ELECTRICAL LEGEND & NOTES

FORT WEAVER ROAD
ROUTE H-1 TO SOUTH OF
FARRINGTON HIGHWAY

CONTRACT CHANGE ORDER NO. 10
HIGHWAY LIGHTING REVISION

FAUSP NO. M-7600(1)

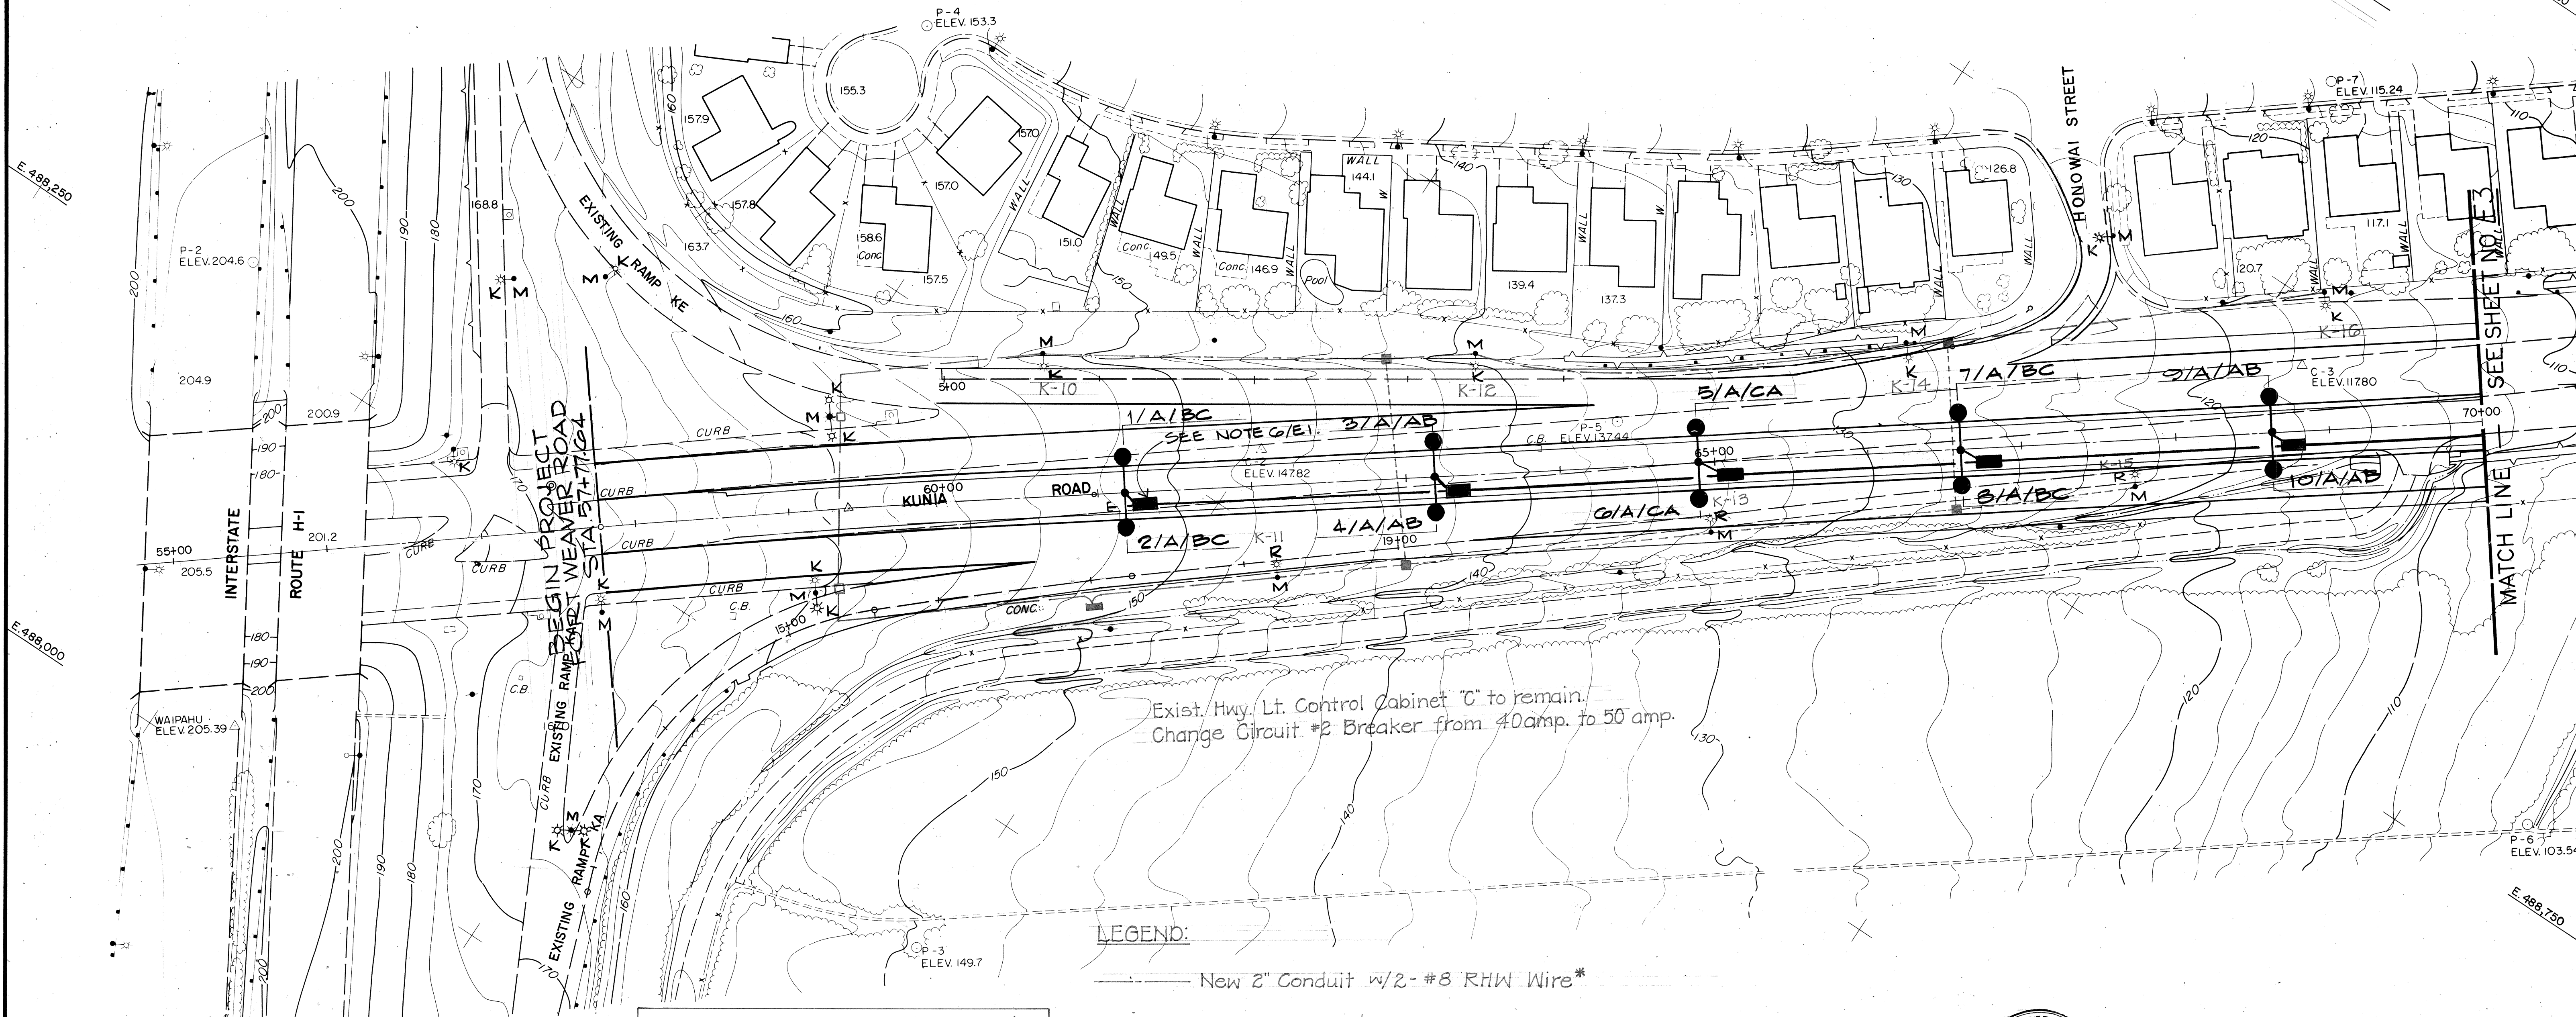
1. Hwy. Lt. Standards K-10, K-12, K-14 & K-16 to remain.
2. Hwy. Lt. Standard K-11 to remain until permanent lights in median are in operation.
3. Hwy. Lt. Standards K-13 & K-15 can be removed after new conduits and wire are installed and lights K-12, 14 & 16 are operational w/new system.

Exist. Hwy. Lt. Control Cabinet "C" to remain.
Change Circuit #2 Breaker from 40amp. to 50 amp.

DETAIL 1/E7 LIGHTING STANDARD FOUNDATION, SLIP BASE (ALL LUMINAIRES EXCEPT #36, #37, #38, #39, #51, #56) SCALE: 1"=1'-0"

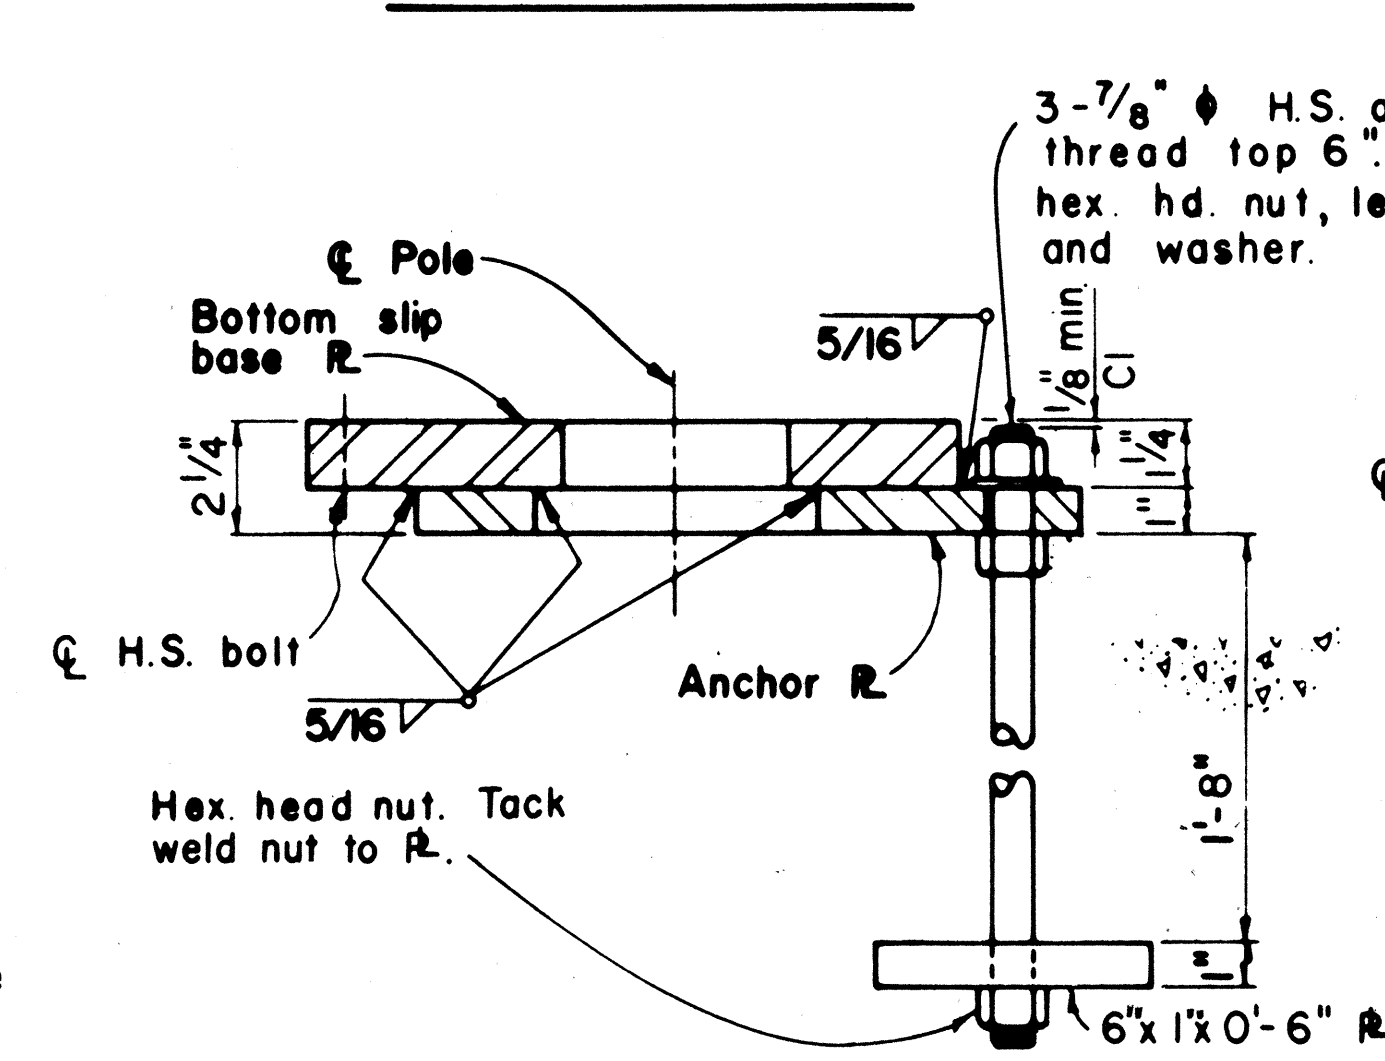
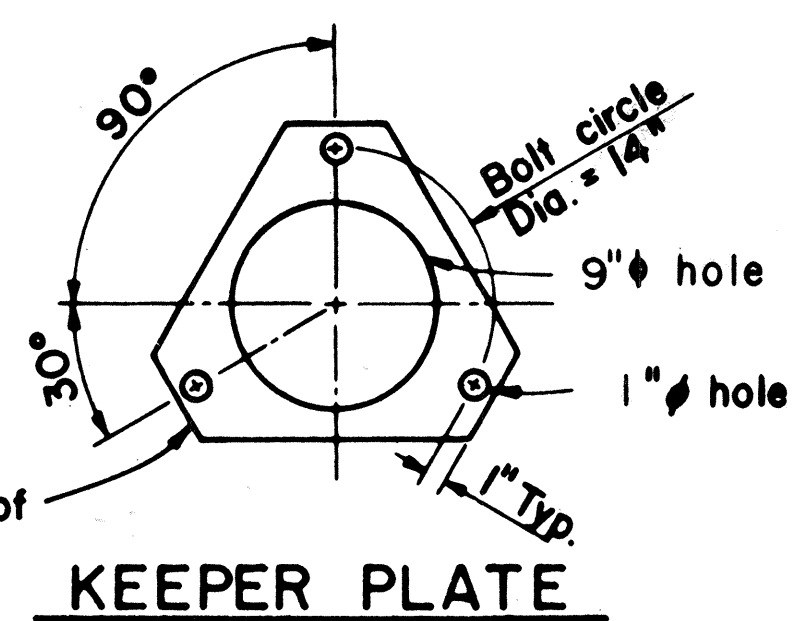
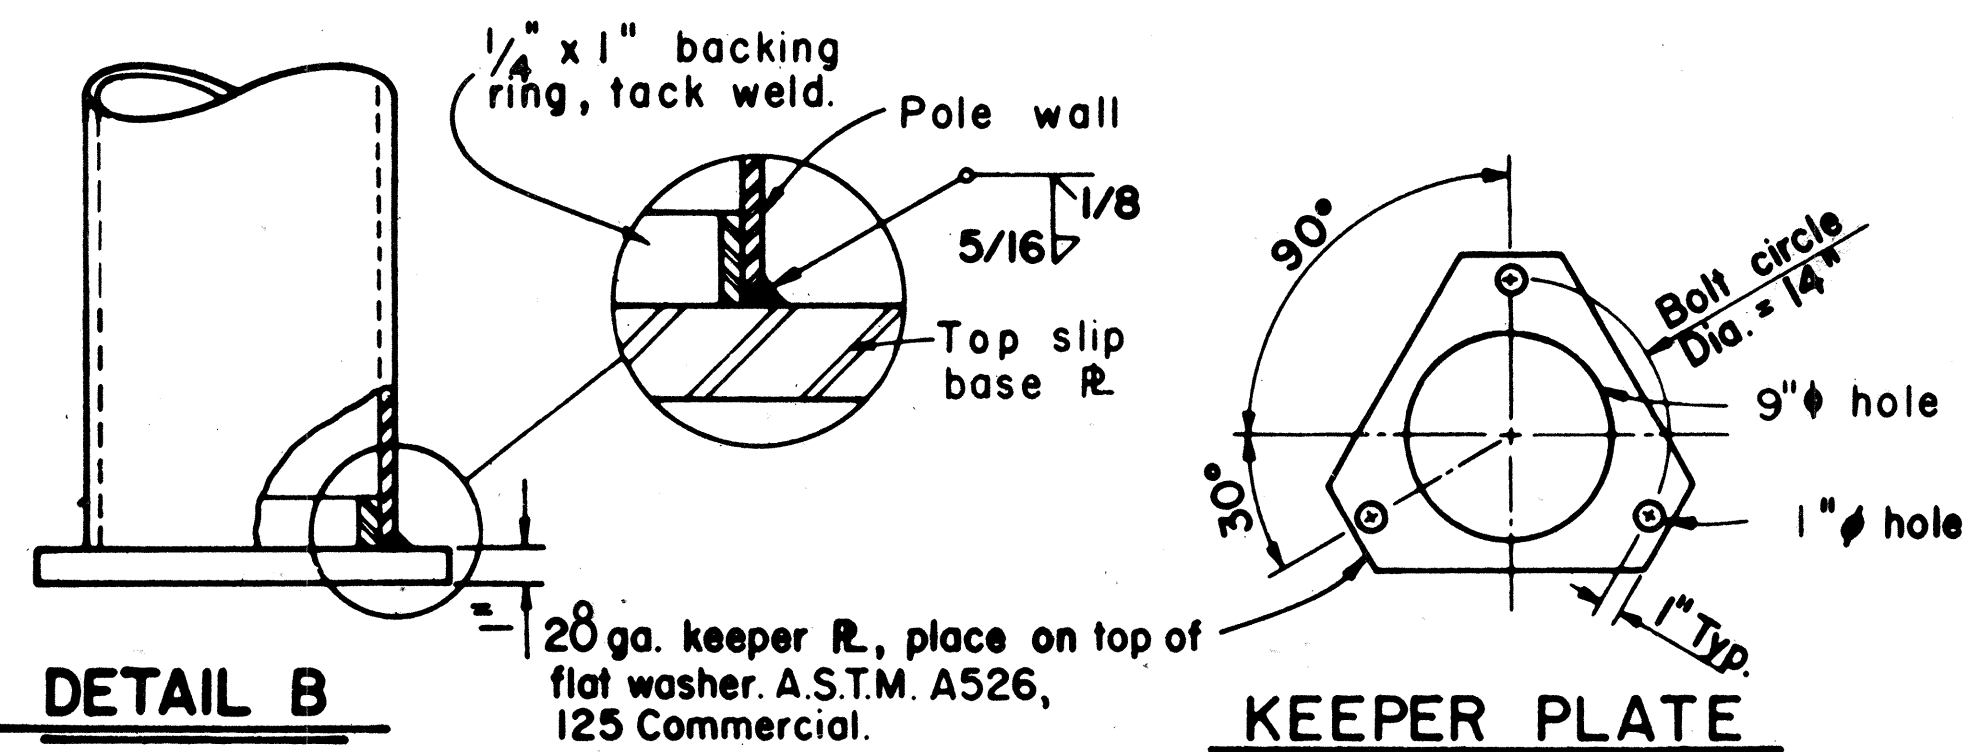
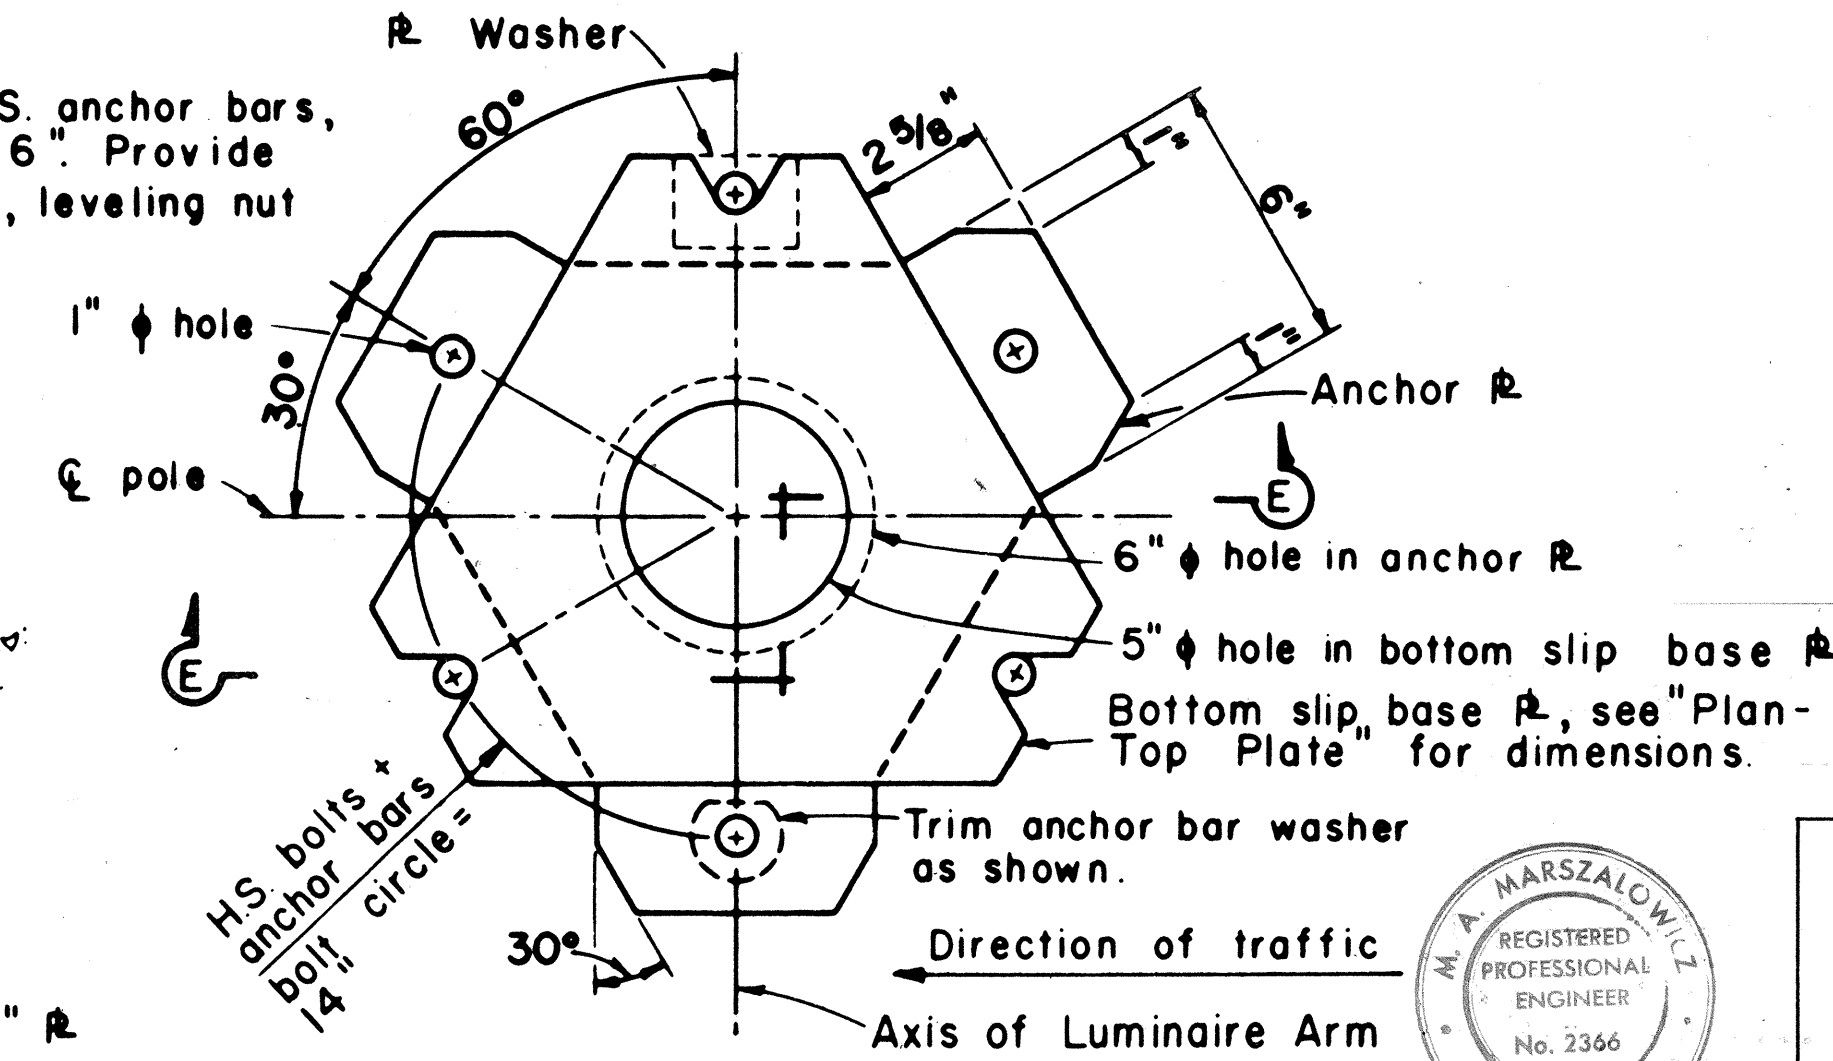
DATE	REVISION
8-9-79	Revised Detail 1/E7 to indicate Slip Base Foundation not applicable to certain luminaires. Revised Detail 2/E7 to indicate 30' setback for Luminaire #56 & provide reference to Detail for Plain Base.
